August 26, 2010

MEMORRANDUM FOR: Jack Guttmann, Chief
Performance Assessment Branch, HLWRS

FROM: Timothy Sippel, Nuclear Engineer **/RA/**
Engineering Branch, HLWRS

SUBJECT: YUCCA MOUNTAIN CONFIRMATORY CRITICALITY CALCULATIONS

Figure 1: Intact Enrico Fermi DOE SNF Canister in a Degraded Codisposal WP

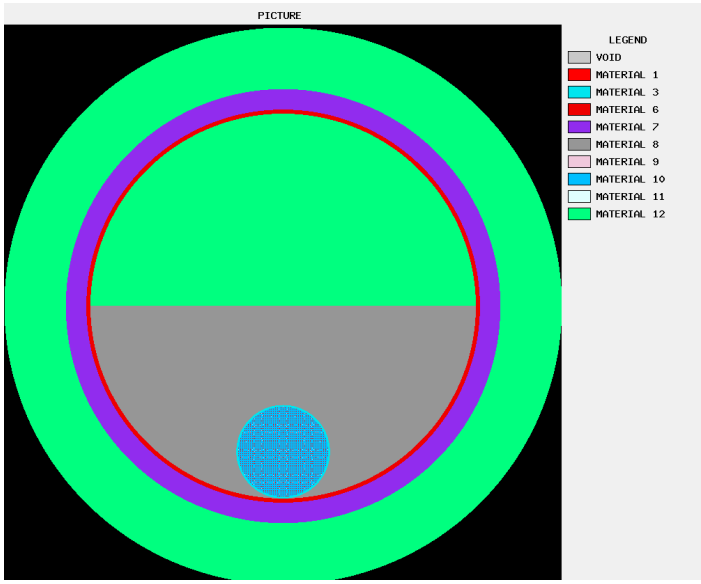
The degraded configuration model shown in the figure below assumes: no gadolinium, more fuel pins than are allowed in the loading plans, and waste package internals reduced to corrosion products. The DOE SNF canister was modeled as still remaining but buried in clay formed of degraded HLW glass and corrosion products.

Our results for this configuration matched DOE's results. As expected of a flooded configuration without neutron absorbers this configuration is critical. So several other configurations were modeled which included degraded (but still present) gadolinium absorbers.

Figure 2: Degraded Enrico Fermi with a Pile of Fuel Rods

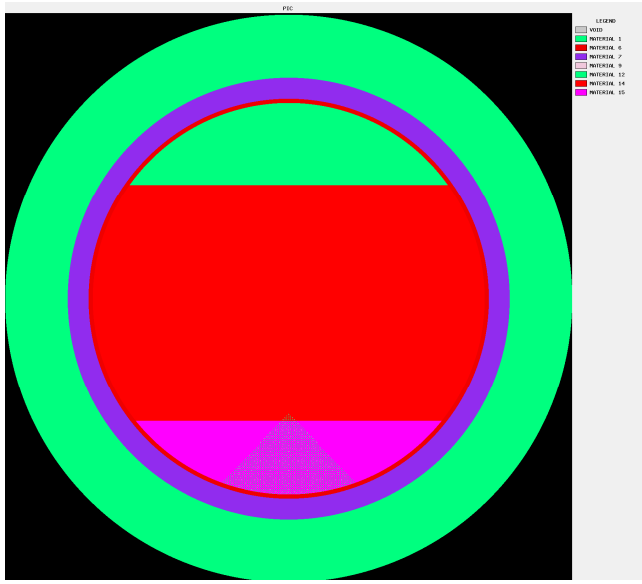
In the model below the DOE SNF canister components, including the gadolinium shot, have degraded and the corrosion products settled to the bottom, with a layer of clay on top. The fuel assemblies are stacked in a loose triangular configuration which is similar to DOE's model that was shown in Figure 5-12 of *Enrico Fermi Fast Reactor Spent Nuclear Fuel Criticality Calculations: Degraded Mode* (MOL.20000802.0002).

Figure 3: k_{eff} vs Gd mass

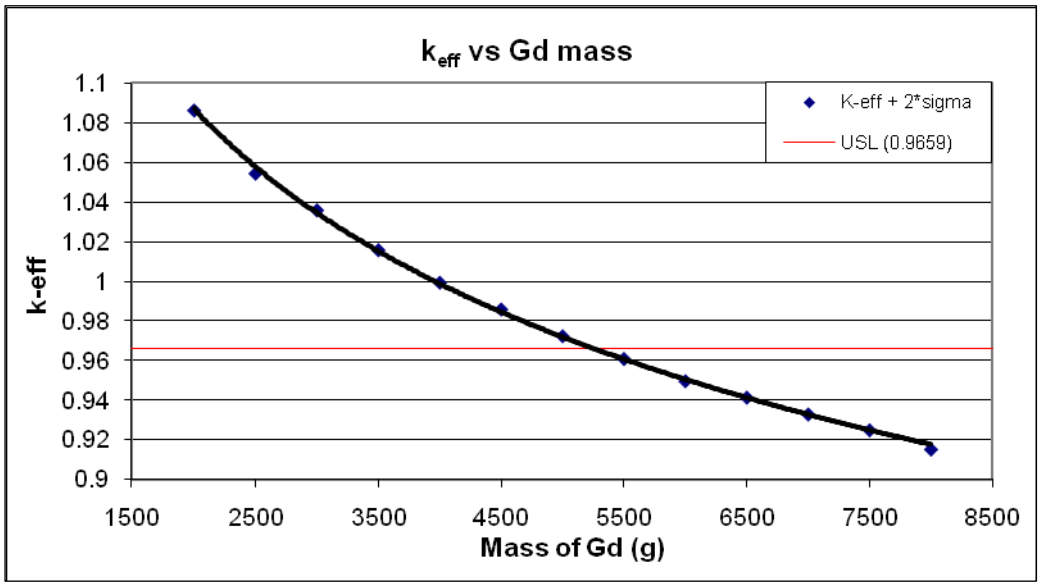
Tianqing Cao performed a parametric study were the amount of gadolinium in the degraded configuration model shown in Figure 2 was varied. The results of this parametric study are shown in the figure below.

None of the configurations modeled by NRC staff exceed the USL with 9 kg of Gd present.
